Serial No. : 10/771,812  
Filed : February 4, 2004

REMARKS

FIG.1

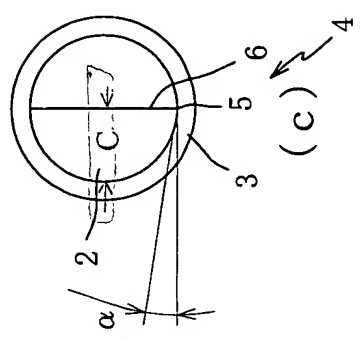
The limitation of "the semi-cylindrical body portion has a half-moon shape in cross section" is supported by the bottom view of Fig. 1(c) which shows a straight line (end cutting edge portion

6) running the center of the circle (tapered end of the cylindrical shank portion 3). The limitation of "the cutting tool cuts the workpiece while being kept unrotated" is supported by the description in the specification, for example, in the paragraphs [0032] and [0038] and the drawing, for example, Fig. 7, which clearly show that the cutting tool 1 cuts the workpiece without rotation. The limitation of "the rake angle of the rake face is  $0^{\circ}$  when cutting the workpiece" is supported by the specification at the paragraphs [0032] and [0038] each of which indicates that the rake face 8 is always held perpendicular to the predetermined direction (moving direction), because, by definition, the rake angle is zero when the rake face is perpendicular to the moving direction, i.e., the rake face is parallel with a tool reference plane throughout the operation.

The applicant has submitted concurrently herewith a request for approval of drawing changes in which reference characters are added to Figs. 1(b) and 1(c) to more clearly describe the shape of the cutting tool.
